Appendix G

GEOTECHNICAL APPENDIX
South San Francisco Bay Shoreline Study (SSFBS)

SUBJECT: Geotechnical Support for Alternatives Evaluation and Plan Formulation

Figure 7 – Blading to create small localized mounds on the side of the crest to temporary raise the effective crest height

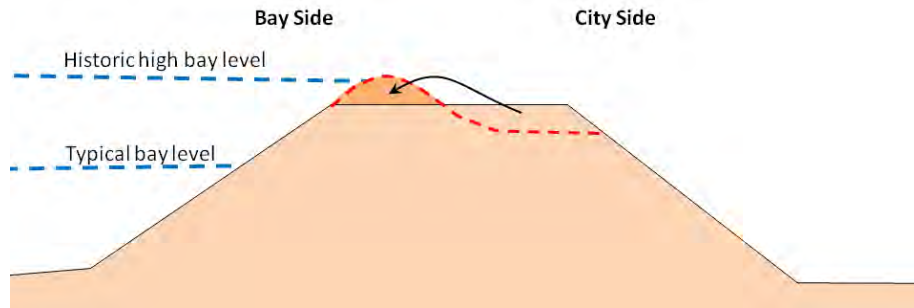
During the field inspection there is evidence that Cargel field operations would scarify or blade crest soil to the bay side of the crest as shown in Figure 6. The apparent purpose of blading was to generate a small temporary raised crest section as illustrated in Figure 7.

A large number of rodent holes were observed in this dike system (see Figure 11). There is also evidence that blading of crest soil was performed to generate small sections having a slightly higher crest elevation (see Figure 6 and Figure 7). There is unknown potential for dike failure due to rodent holes or failure through small elevated crest sections, as illustrated in Figure 14.

Figure 14 - Hypothetical section showing soil moisture contents, near surface instability, and rodent dug holes, and potential modes of failure.

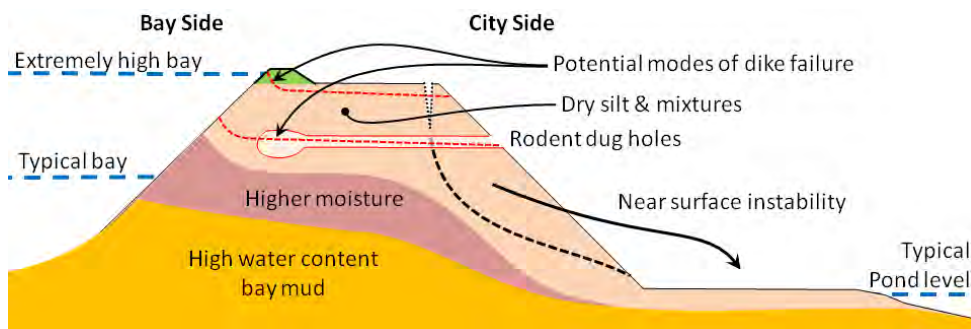
The combination of rodent holes and dry highly erodible silt soils together provide a dangerous condition because either or both in combination can cause erosion failure along an upper section of the dike (as illustrated in Figure 14).

Figure 20 - Geotechnical Consultant's representing of the Bay Mud strength in terms of Bay Mud zones?

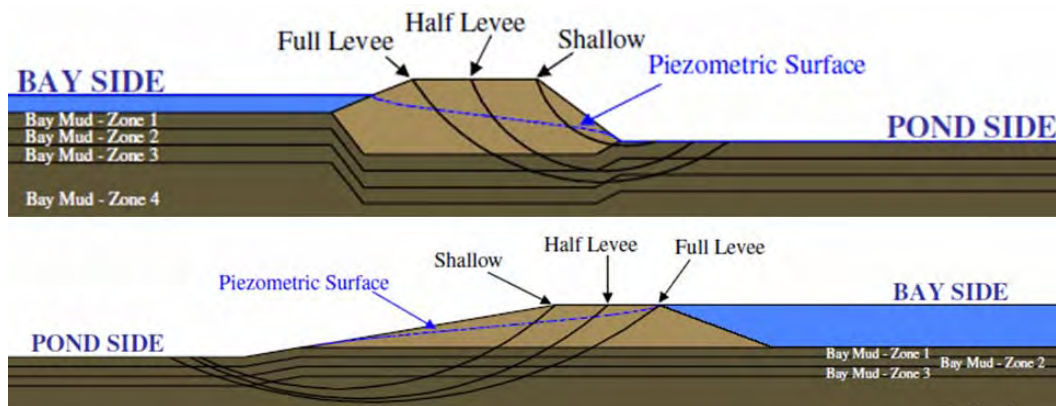
San Francisco bay mud strength characteristics have been well studied academically. The project geotechnical reports describe evaluation of bay mud strength based on laboratory strength tests (from boring retrieved soil samples) and predicted strengths from CPT. The soft bay mud under the dikes have experienced clay consolidation causing settlement of the dikes. This consolidation results in a strength increase under the dikes compared to bay mud deposits at same elevation beyond the dike, as shown in Figure 19. The reports don't show any analytical effort comparing strength for bay mud under the dikes to a soil column in the water beyond the dikes. It's unclear if and how the bay mud layers shown in Figure 20 were used to assign undrained strengths. A technique called the equivalent depth method could be used for comparing undrained strength versus vertical effective stress below the dike to adjacent underwater deposits. From review of the reports it cannot be discerned if the established project soil strength for the bay mud is realistic, conservative, or unconservative.

The geotechnical consultants spent a lot of effort performing geotechnical stability evaluation. The highly variable dike shape and crest heights were measured at numerous locations and then a generalized dike shape was used for slope stability analysis. It's unknown if the proper strengths (as discussed in previous sections on dike soil strength and bay mud strength) were used for stability evaluation. A hypothetical non circular slope instability failure surface is illustrated in Figure 21 based on realistic contours of strength under the dike. The geotechnical evaluation studies conclude that landslides are of low relative potential given the dike geometry and assuming that the soil strengths are realistic.
